ABEX CORPORATION
INDUSTRIAL HYGIENE SURVEY
FRICTION PRODUCTS GROUP
LINCOLN, ONTARIO
FEBRUARY 10-14, 1975

INDUSTRIAL HYGIENE CORRECTIONS REQUIRED

Fig. 4-13

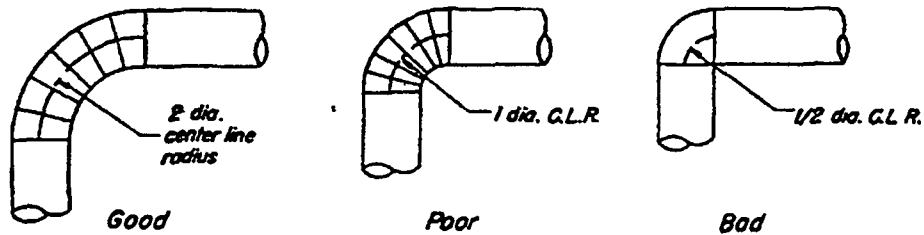
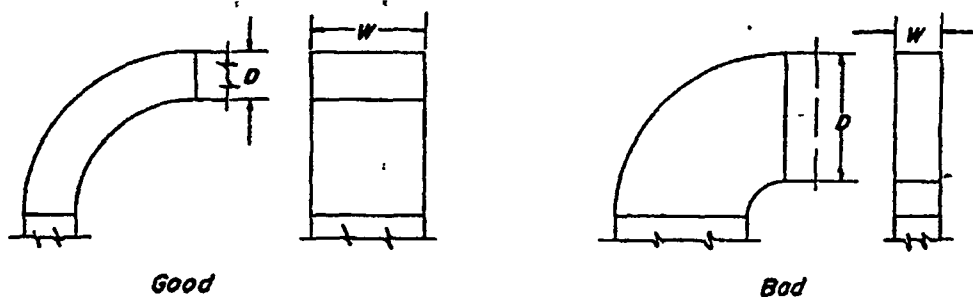
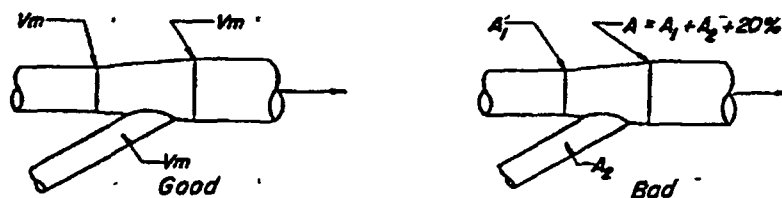
At Blok Press, there are essentially two sources of exposure which require control. The preformed bloks which arrive at Blok Press on the tiered racks are coated with fine dust containing both asbestos fibers and lead compounds. Any amount of disturbance or handling, such as transfer to the press platform, results in airborne dispersion of the dust. A vacuum system or exhausted blow-off enclosure should be provided to clean the preformed bloks prior to transfer to Blok Press. If possible, such a blow-off or vacuum device should be incorporated into the blok preform enclosures to include protection of these operators. The second source of exposure at Blok Press occurs on the vertical lift when the operator applies the graphite lubricant with the spray gun. This not only disperses asbestos fibers into the operator's breathing zone, but graphite-surfactant aerosols as well. This latter material accounts for a majority of the undesirable, dirty aspects of this operation. To collect both contaminants, side slot hoods connected to modified, flexible travel-vents should be installed on the edge of the press platforms across from the operators' positions. The hoods should include tapered plenums and three rows of slots with velocity in excess of 2,000 fpm at the lowest slot. (Refer to Fig. 4-13 for suggested design.)

- 75-4 The blok press operators are exposed to asbestos and graphite-surfactant aerosols on the platforms while loading the presses. High velocity slot exhausts should be considered for installation on the opposite side of the loading platforms to remove these air contaminants.

Fig 6-20

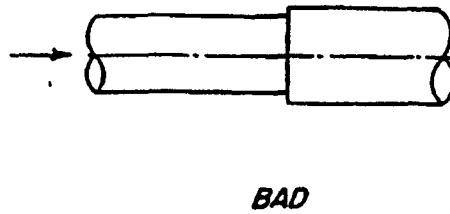
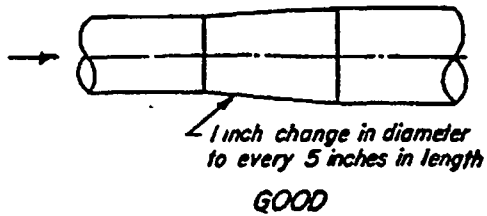
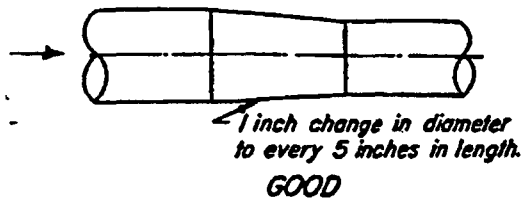
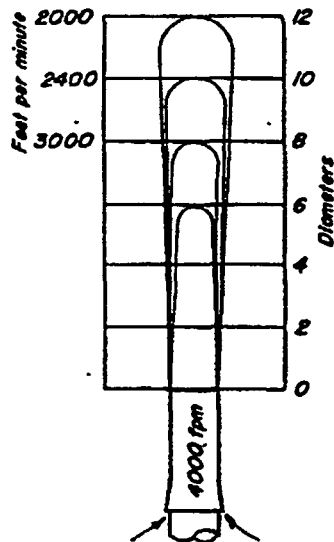
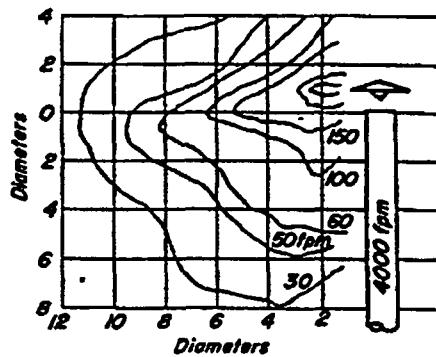
the Finish Department where branch ducts terminate in open ended exhaust trunks which are either pushed out of the way and not used or placed in the vicinity of the point of dust generation. Either way, dust capture is minimal, and air volumes and energy are being wasted. The trunks should be connected to hoods or enclosures which surround the sources of dust release. Where trunks are unused or serve no purpose, they should be disconnected at their point of entry into the main duct and the opening sealed in a manner to prevent additional friction loss. Although mains and branches are basically well designed and amenable to systems balancing, ductwork should be thoroughly checked to insure that principles of good duct design are consistent throughout. Where elbow radii, aspect ratios, duct sizes, branch entries, duct enlargements, and duct contractions do not correspond to the appropriate examples in Figures 6-13, 6-20, and 6-22, redesign should be considered prior to systems balance.
